HAMMARLUND HX-50 TRANSMITTER/EXCITER - ADDENDA

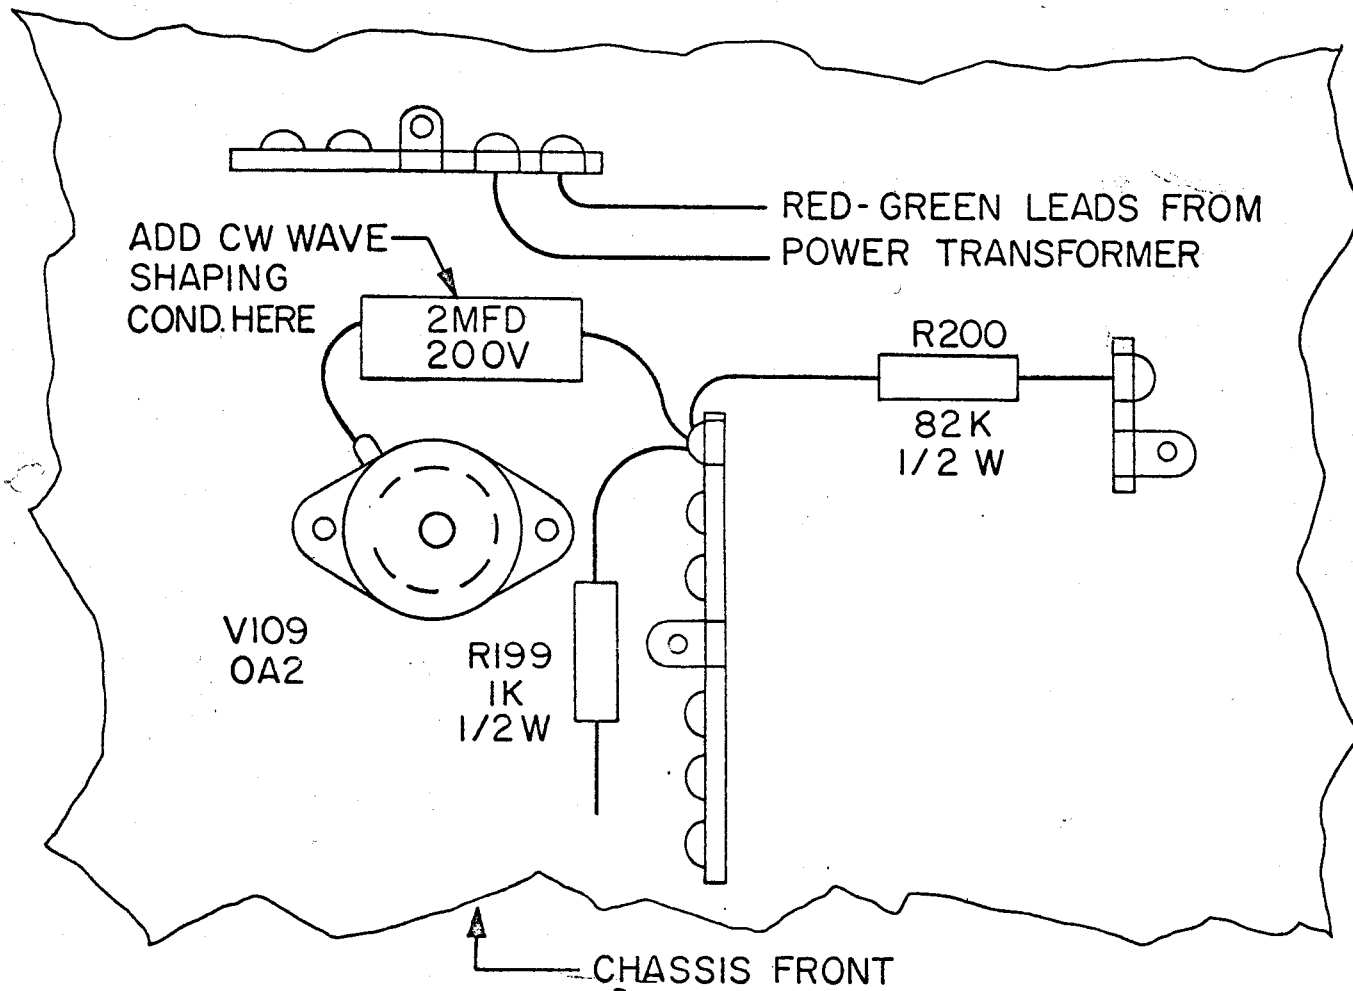
TO INCREASE VOX SENS.

INSTALL A 47K 1/2 WATT RESISTOR BETWEEN C110 AND THE JUNCTION OF T102 AND R113. (SEE ATTACHED DRAWING).

TO REDUCE KEY CLICKS

CONNECT A 2 MFD 200 V. CAPACITOR BETWEEN THE JUNCTION OF R199 AND R200 AND GROUND. (SEE ATTACHED DRAWING).

NOTE: IF A ELECTROLYTIC CAPACITOR IS USED THE POSITIVE TERMINAL SHOULD BE CONNECTED TO THE CHASSIS (GROUND).
